ADDRESSEES	: Owners and operators ABC Customer Care and Parts Source
VEHICLE MODEL	: CX45 and TX45 with DD13 EPA16 engine
MANUAL SECTION	: 14.10 Electricity – wiring
BULLETIN TYPE	: Field Change Program
DATE	: February 18th, 2019
SUBJECT	: To change and reroute alternator ground cables
TERMS & CONDITIONS	: Refer to the warranty section further in this Bulletin.

DESCRIPTION:

Figure 1: Routing of alternator ground cables

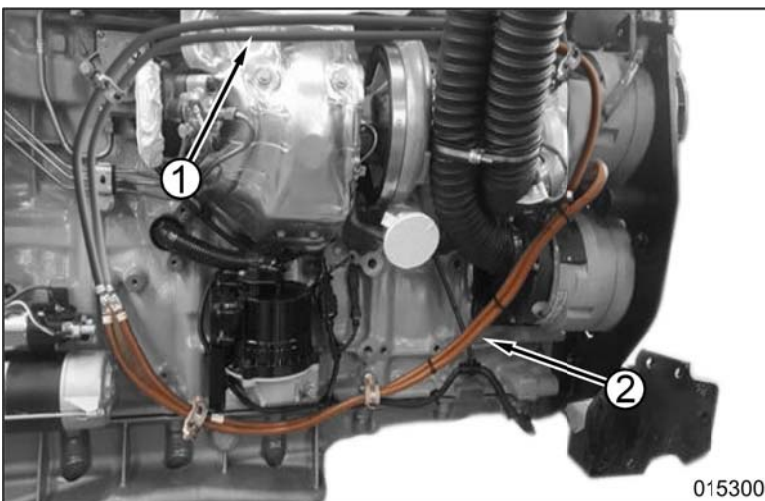
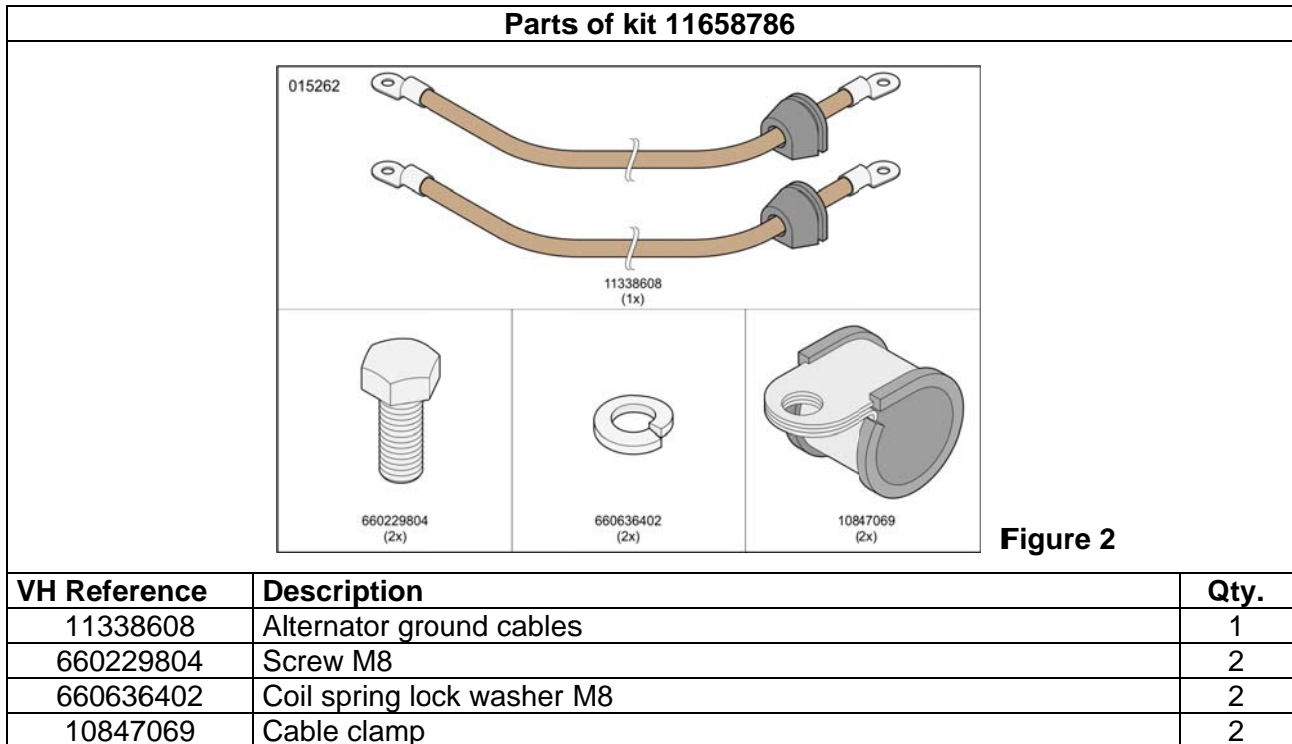
It has been reported that the ground cables of both Prestolite AC172 alternators are too close to the exhaust pipe and turbocharger (refer to 1-Figure 1). The ground cables insulation might suffer damage due to excessive heat.

This Service Bulletin gives step-by-step instructions to change the alternator ground cables and reroute them under the crankcase breather unit (refer to routing 2-Figure 1).

- 1. Previous routing (= not OK)
- 2. New routing (=OK)
